Service Bulletin

ENGINE COOLANT LEAK FROM LOWER RADIATOR HOSE

Bulletin No: 01-008/16

2007-2015 CX-9

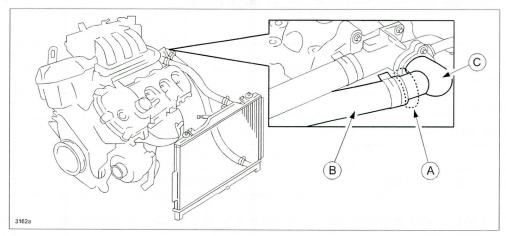
Some vehicles may exhibit an engine coolant leak (A) between the lower radiator hose (B) and the thermostat housing (C).

The lower radiator hose has been modified to improve sealing performance.

- 1. Verify the customer concern.
- 2. Replace the lower radiator hose with a new part according to the instructions on MS3 online or the Workshop Manual (section 01-12 RADIATOR REMOVAL/INSTALLATION).
- 3. Verify the repair.
